23 May 2011

NIRB File No. 11RN017
NWB File No.: 2BB-MEL0914
KIA File No.: KVRW11F02 and KVCA11Q01

Re: Opportunity to address comments received regarding AEM's "All-Weather Road" project proposal

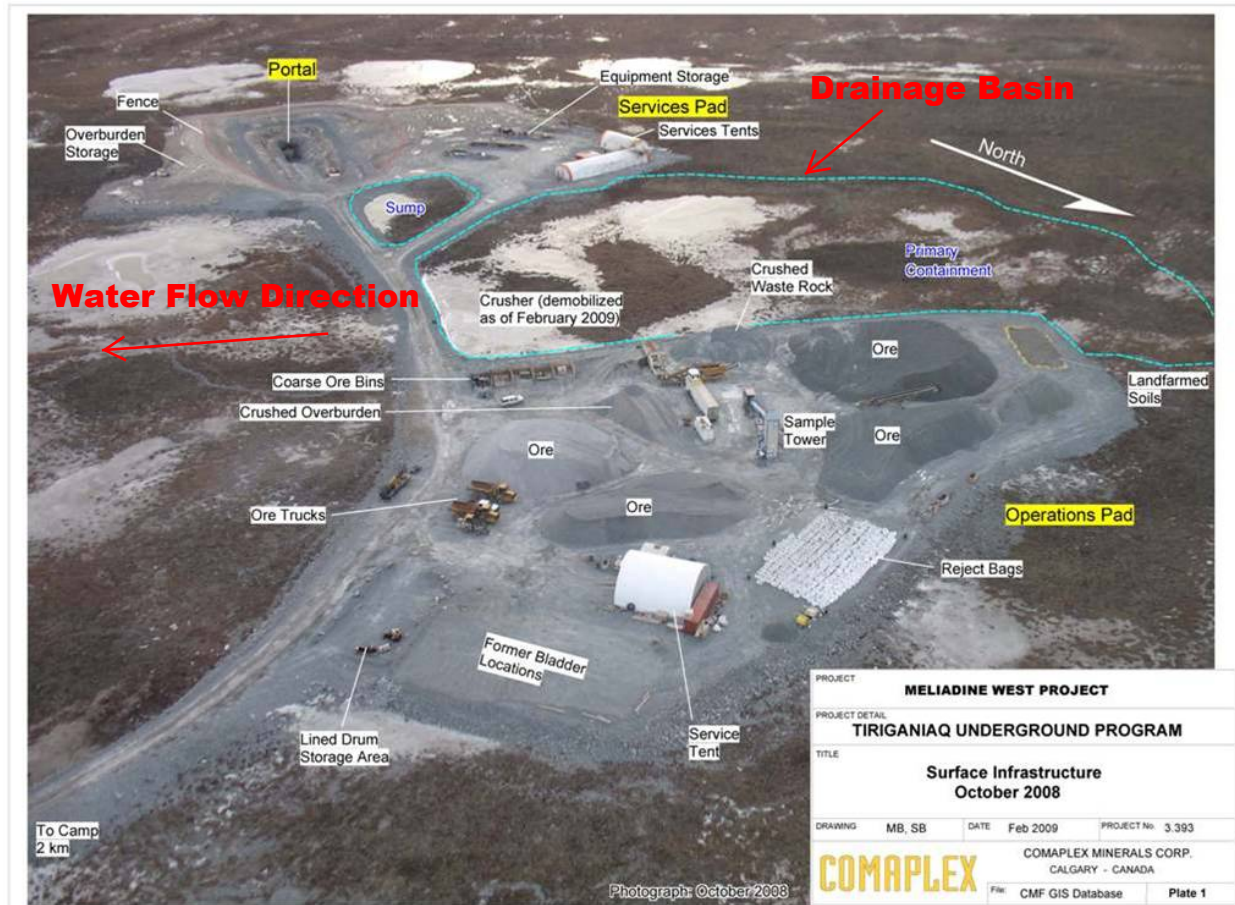
- i) It is not clear that the assessment of metal leaching is adequate. It appears that the proponent dismisses leach test results obtained through static testing that indicate exceedances of "Canadian Water Quality Guidelines for the Protection of Freshwater Aquatic Life" as not necessarily reflecting what will actually happen in operation. No field tests are available at this time and it the Proponent appears to suggest that water quality monitoring at the Primary Containment Area can be used to estimate future results. The Proponent does not explain or substantiate of the adequacy of this or explain and how the use of this proxy may affect the certainty of the results. The Proposal states that the proponent will have a better understanding of the potential for metal leaching after future data collection. As a result, INAC is not certain whether the proponent believes that its current understanding of the potential for metal leaching is sufficient for the purposes of impact assessment. If the proponent believes that its current understanding is sufficient at this stage, the proponent should explain and substantiate this conclusion.*

- ii) The Primary Containment Area (PCA) is not described. INAC presumes that the proponent is referring to the containment area associated with the proponent's proposed underground exploration program, however as this is a separate NIRB process, it would be helpful if the proponent clarified what the PCA refers to, especially as it appears to be a crucial element of this section of the Proposal.*

The proponent states that "Monitoring of the PCA and various water bodies in the immediate vicinity of the PCA will continue in 2011." However the proponent does not identify these water bodies, or state the methodology by which they were or will be selected. The proponent has also not provided a monitoring plan.

Plate 1 shows the Primary Containment Area, its drainage basin and the direction of water flow. The area of the drainage basin is 14.2 hectares. The average yield is approximately 100 mm resulting in an estimated annual runoff volume of 14,400 m³ per year. Ice can be seen in Plate 1 against the operations pad and the road between the two pads. The pads are sloped to drain into the PCA. The rock type used in building the pads and the roads is a greywacke/siltstone. This material, along with other types of waste rock, underwent static (geochemical) testing by Golder Associates.

Figure 1 shows the water sampling location in the PCA and water bodies that are monitored downstream. The direction of flow from the PCA is into Lake A54 followed by Lakes A38 and A8, all of which are monitored. A parallel path from Lake A15, Lake A13, Lake A9 to Lake 8 is also sampled but receives no water from the PCA or the pads.
